Addendum No. 2

Reference: Regional Training Institute – TASS Phase 2
Utah National Guard – Camp Williams, Utah
DFCM Project No. 11020480

ISSUE DATE:	1 April 2013
RESPONSE TO:	Contractor Requests for Information & DFCM Comments
PROJECT:	**RTI TASS Complex, Phase II** **Administration & Billets Buildings** 17800 South Academy Street Utah National Guard Camp Williams **DFCM'S PROJECT #:** 11020480 **NGB'S PROJECT #:** 490444 **ARCHITECT'S PROJECT #:** 11024
OWNER:	**Utah National Guard** 12953 South Minuteman Drive Draper, Utah 84020-1726
SUBJECT:	**VARIOUS CLARIFICATIONS**
ATTACHED:	**VOLUMES A.1 & A.2**

A1 LEVEL 1 - LIFE SAFETY PLAN
GI101 1/16" = 1'-0"

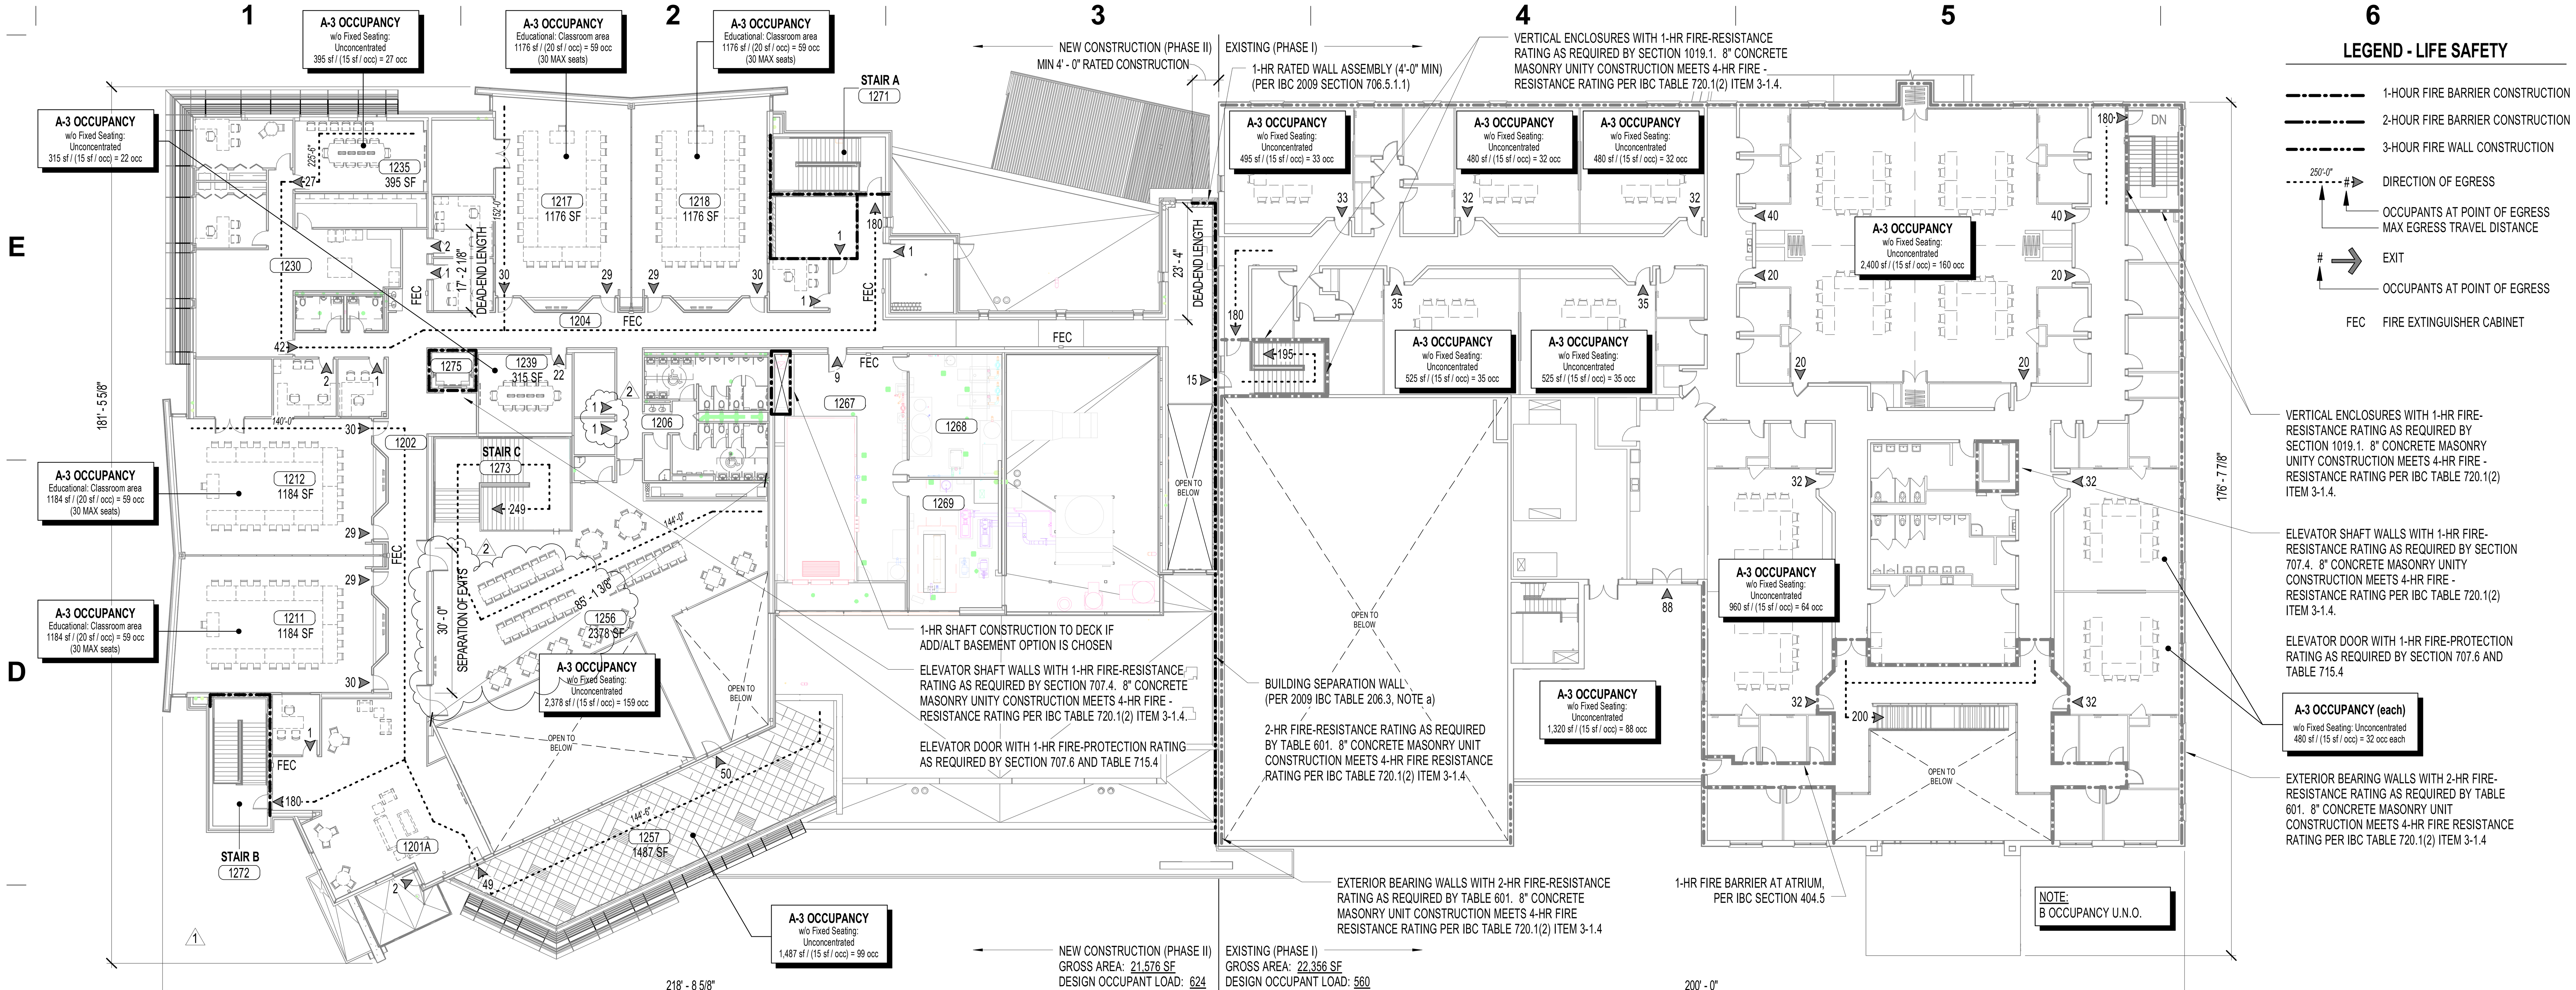
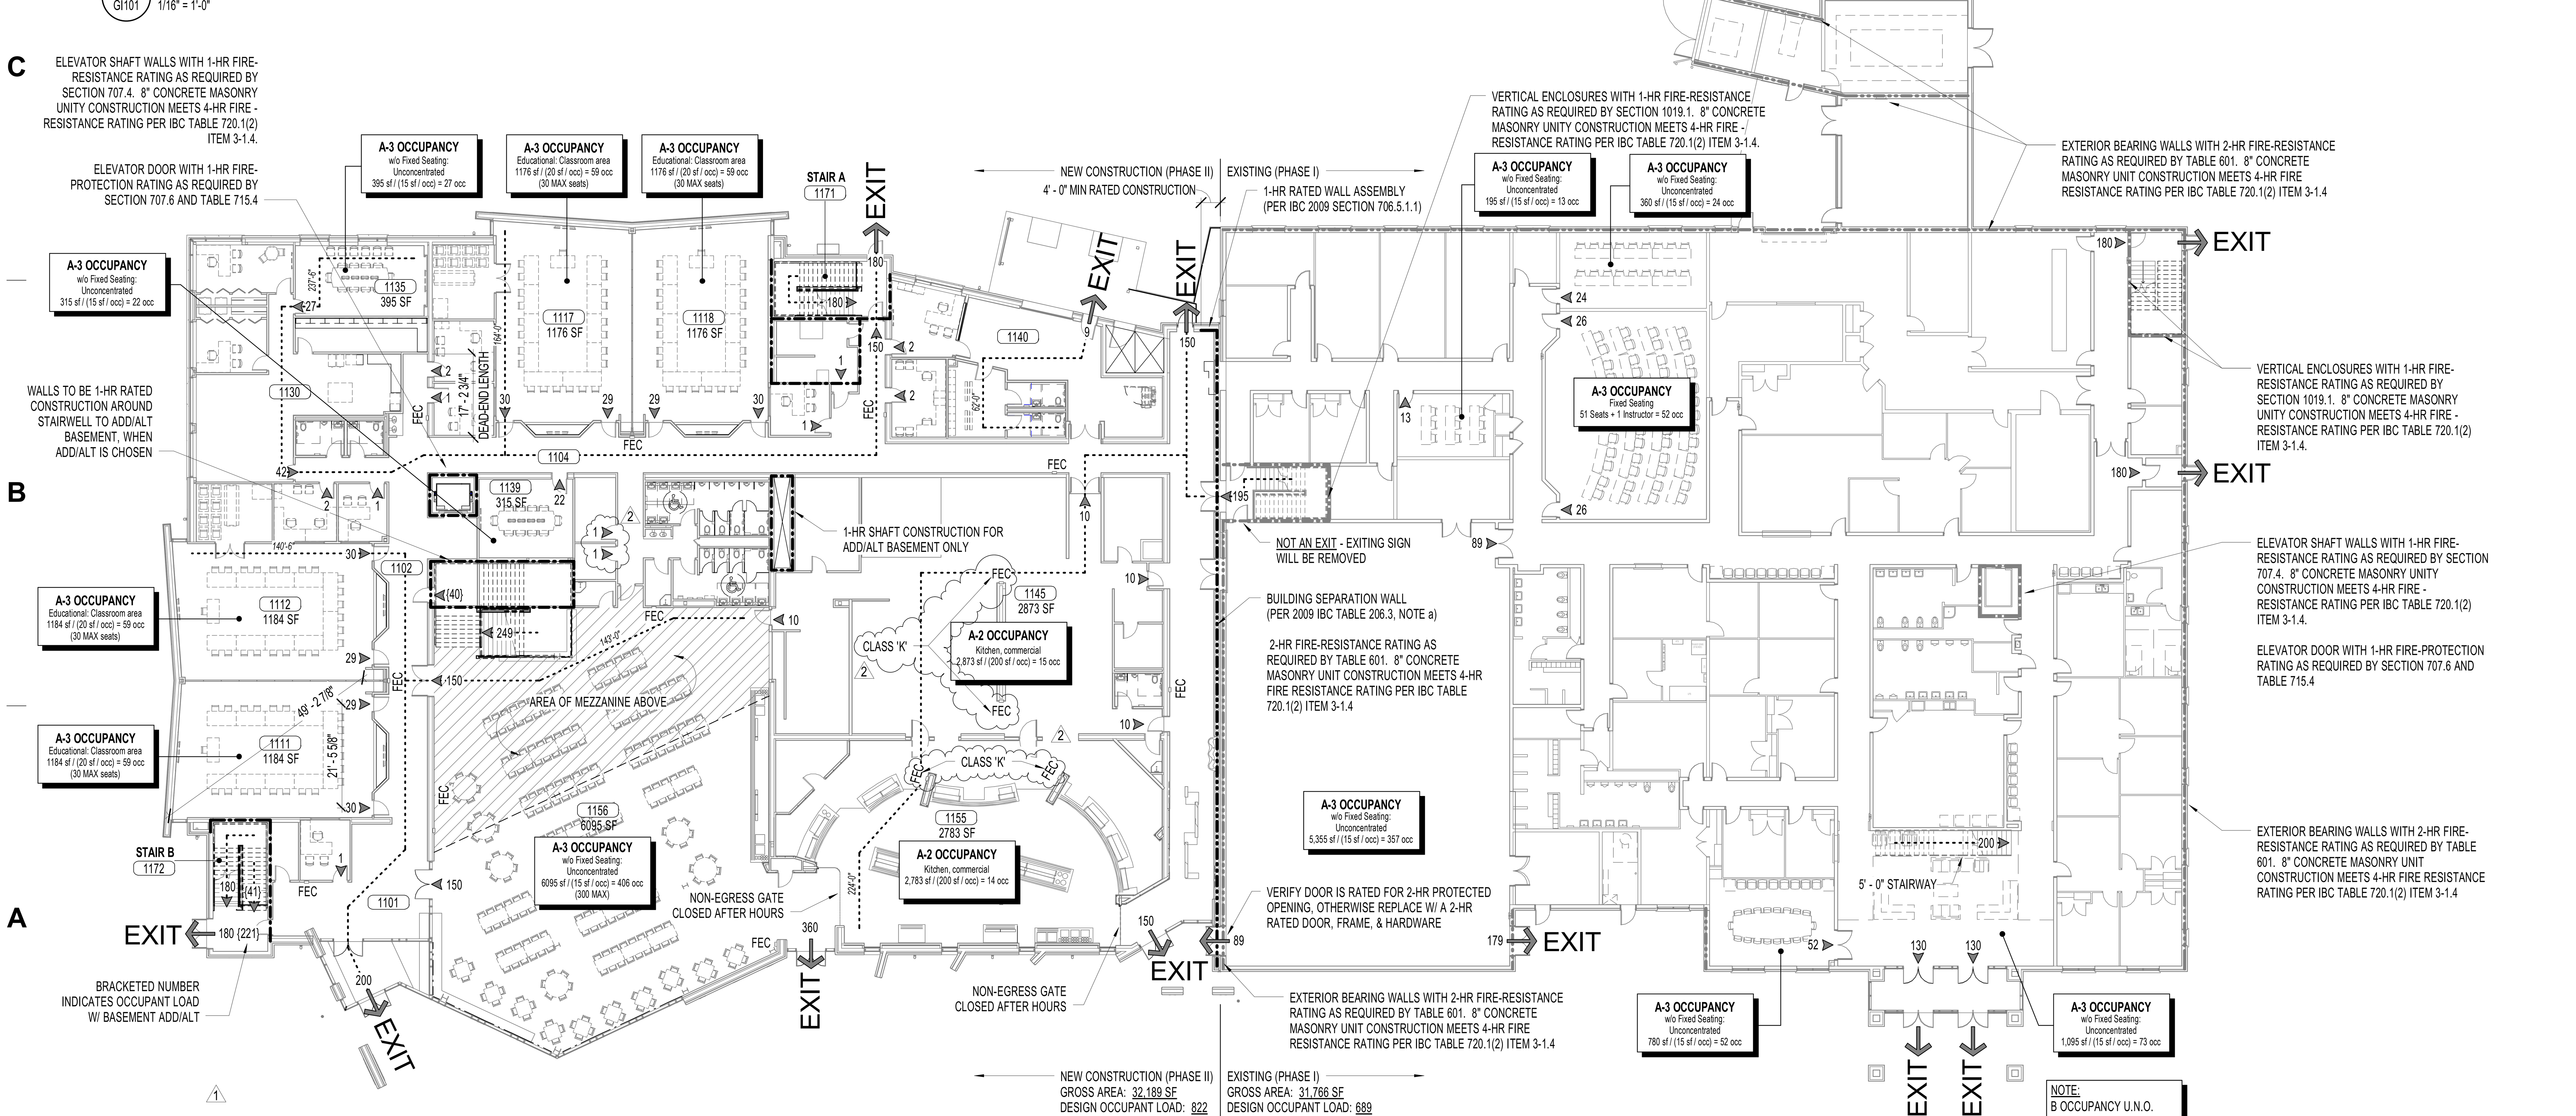
Item #	Sheet(s)	Amendment
A1.01	GI002.1, GI002.2	**ADD** sheet GI514 to the sheet index.
A1.02	GI101	**REVISE** sheet as provided.
A1.03	GI110	**ADD** the following to the DEFERRED SUBMITTALS LIST: • FIRE ALARMS…… 6 MONTHS
A1.04	GI505	**REVISE** wall type 'SS42' to be wall type 'SS42T', as shown in sheet provided.
A1.05	GI512, GI513, GI514	**REPLACE** sheets GI512 and GI513 with sheets provided. **ADD** UL Design No. U415 to sheet GI512, which rearranges details to next subsequent sheet. **ADD** sheet GI514, as provided.
A1.06	GI701	**REVISE** dimension on detail A6/GI701 to read "60" MIN, CLEAR" for distance from the plumbing wall. Clearance dimensions should now be 60" in both directions.

1 / SB100 ADDITIVE / ALTERNATE FOOTING AND FOUNDATION PLAN

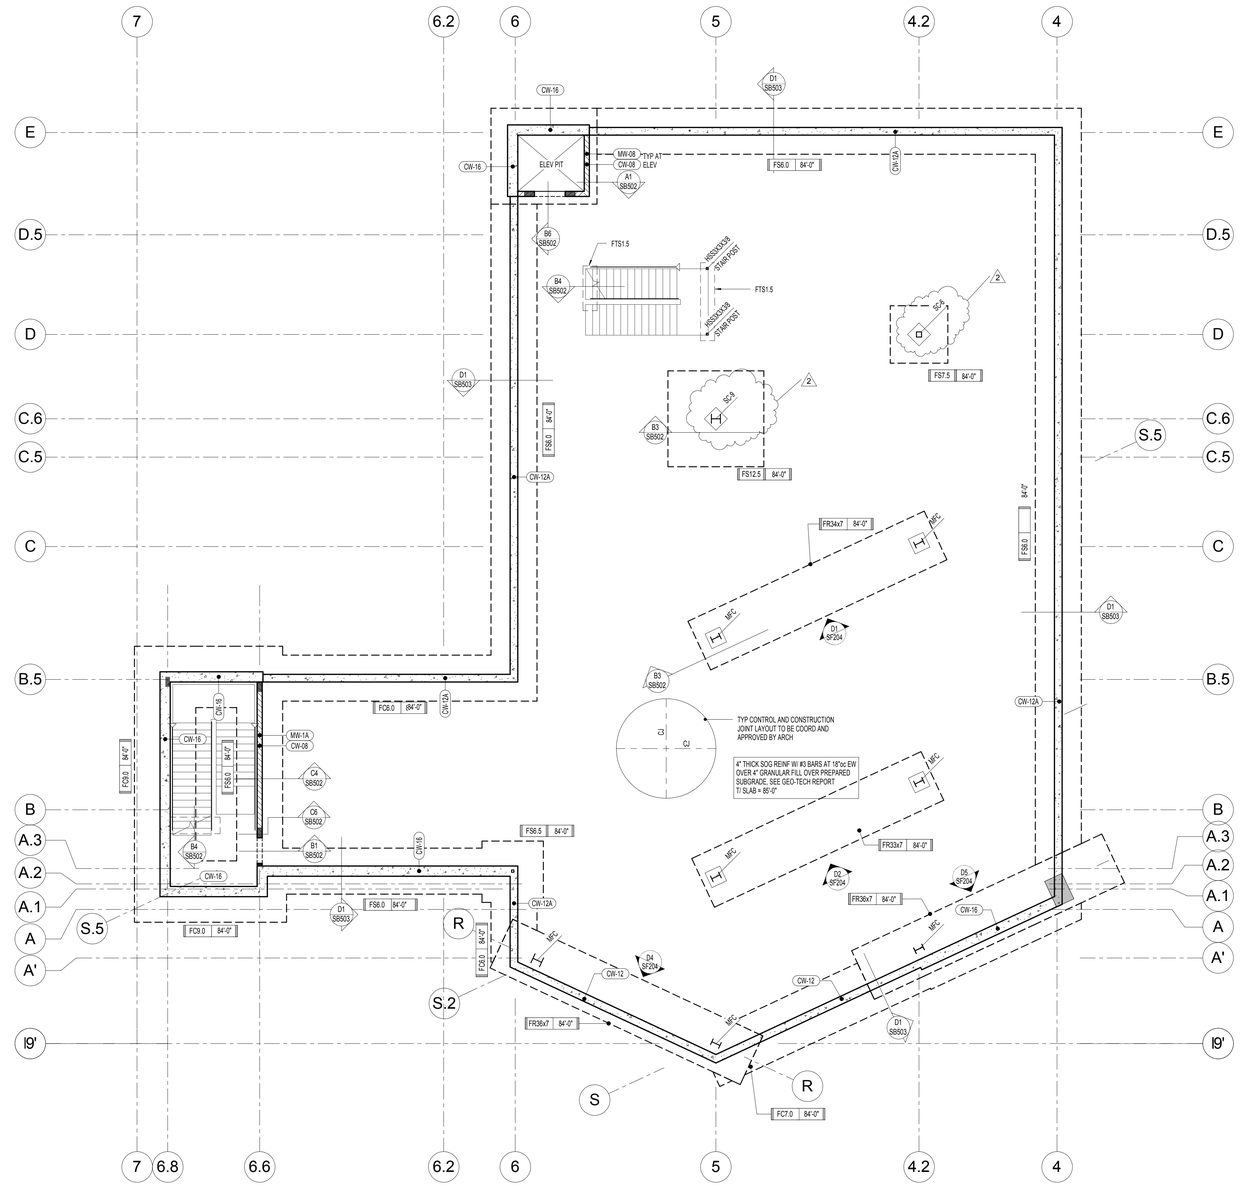
3. Drawing SB100 – Added callout labels to steel columns. Corrected section cut callout, and footing label callout. Corrected drawing references in Footing and Foundation Plan Notes, and in the Marks and Symbols.

1 FOOTING AND FOUNDATION PLAN
SB101 SCALE: 1/8" = 1'-0"

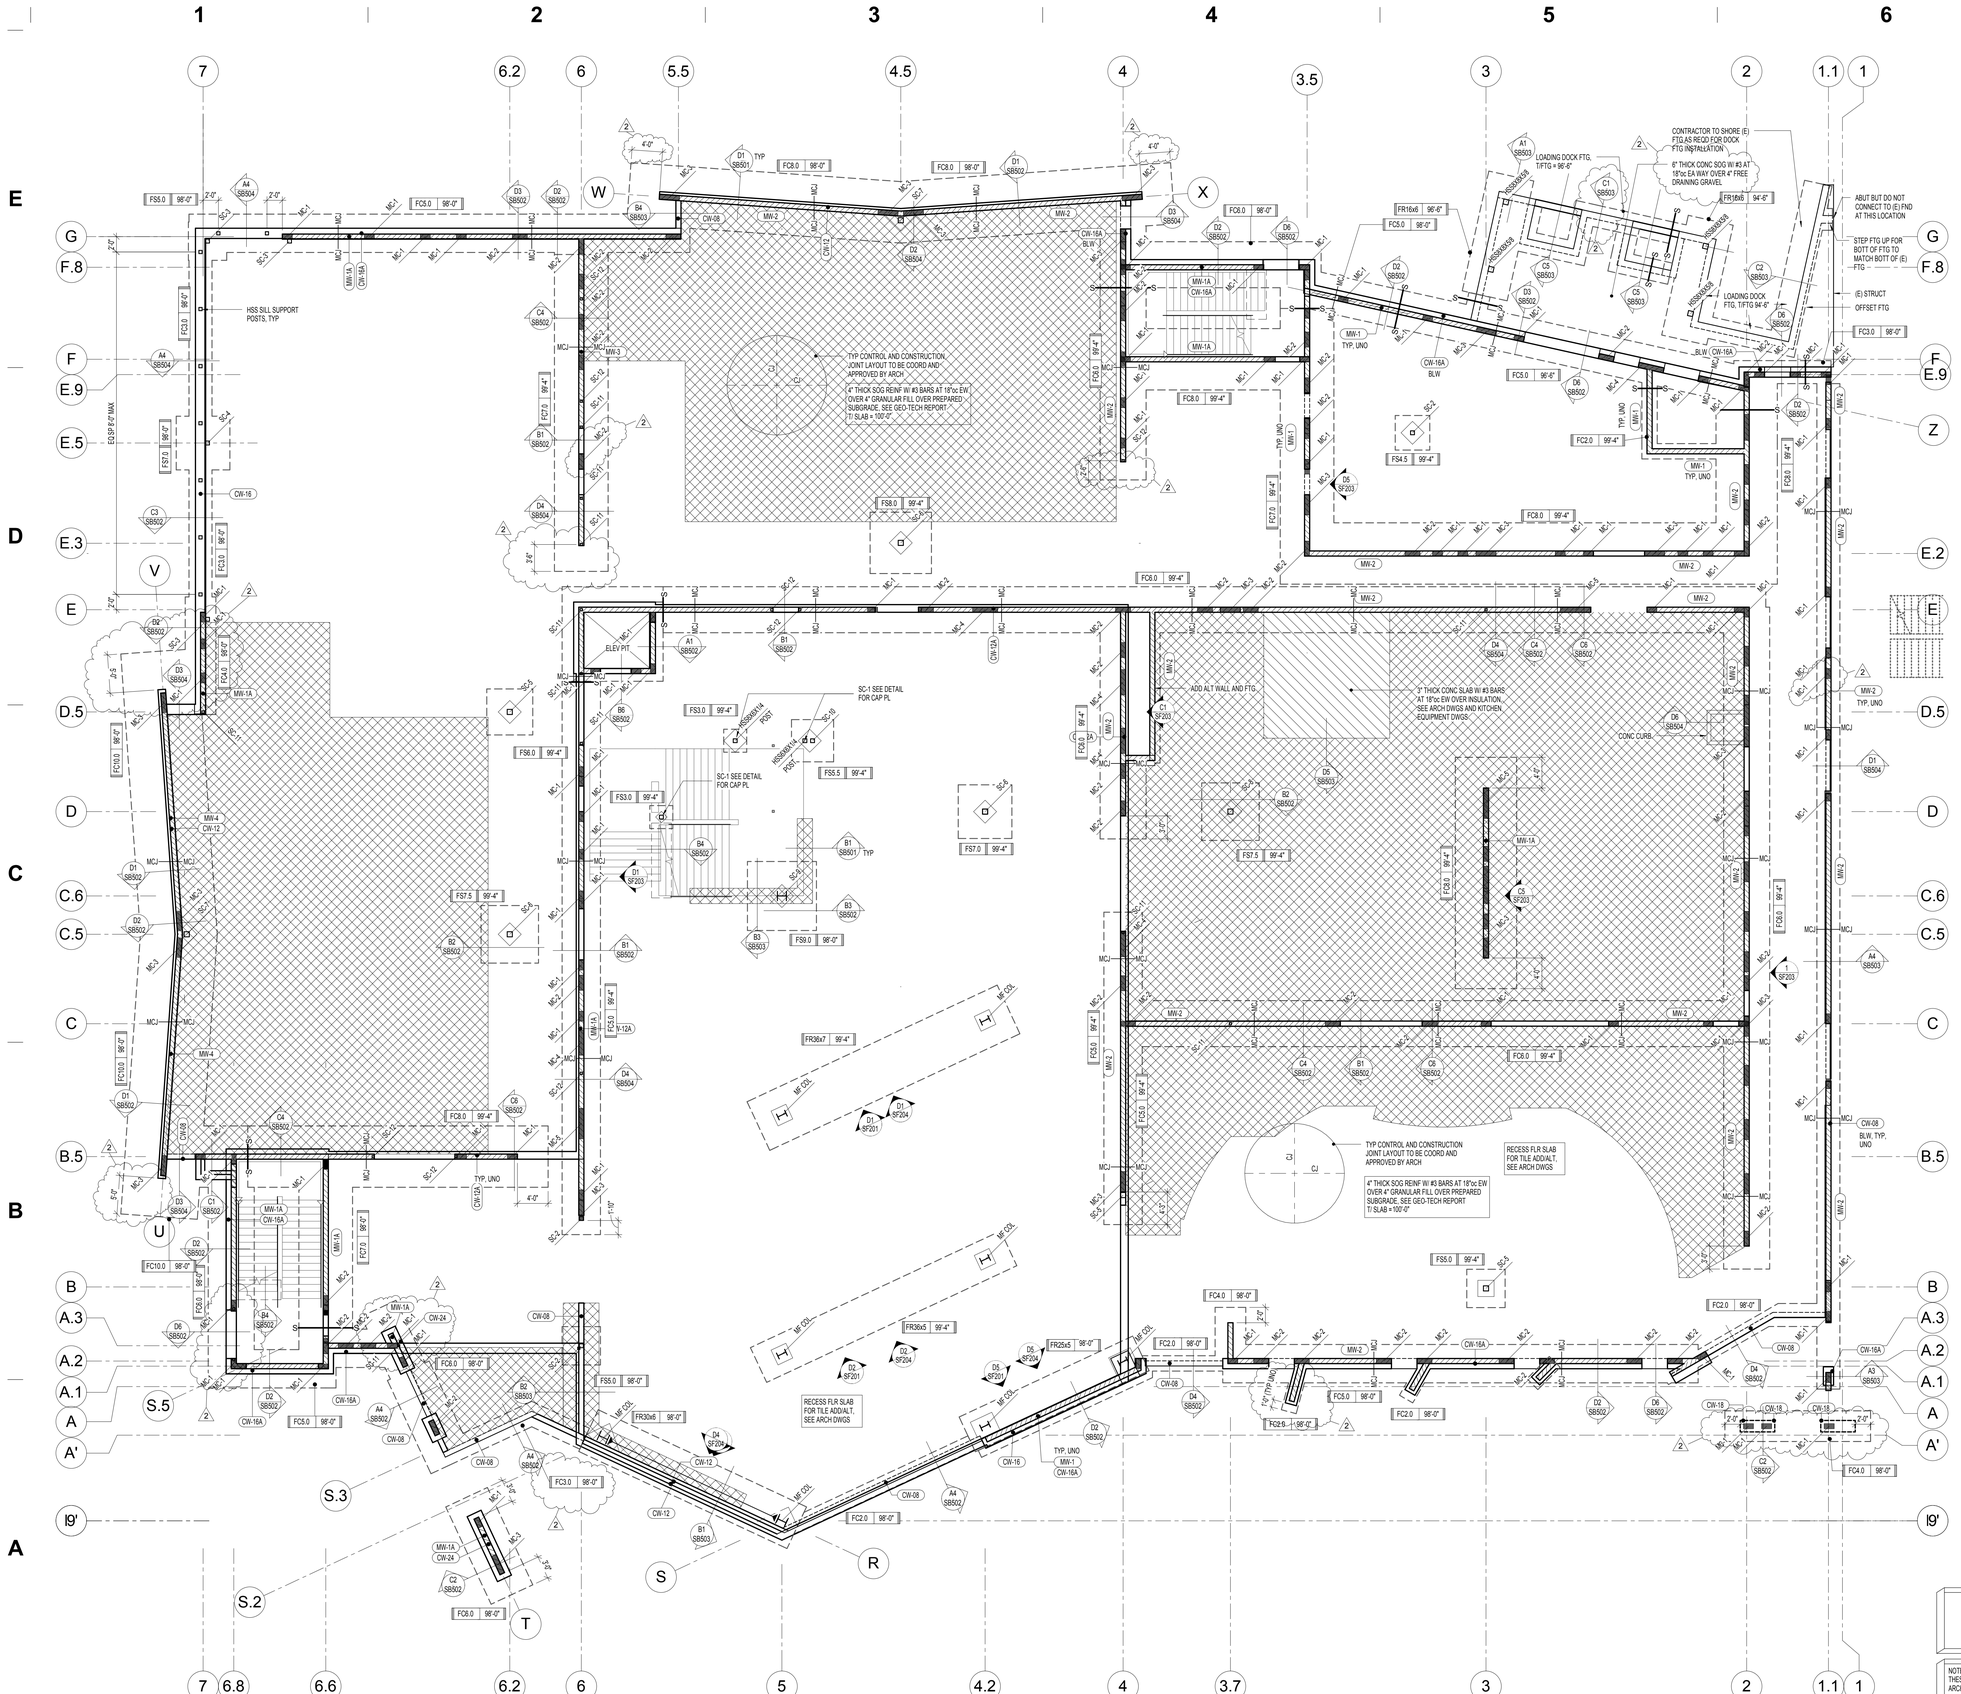
4. Drawing SB101 – Added and corrected dimensions to continuous footing ends. Added missing masonry column callouts. Added missing concrete wall callouts. Deleted SC-12 columns on Grid 6.8. Added missing footing callout on Grid S.3. Added section cut to loading dock area. Increased loading dock slab on grade thickness to 6". Corrected drawing references in Footing and Foundation Plan Notes, and in the Marks and Symbols.
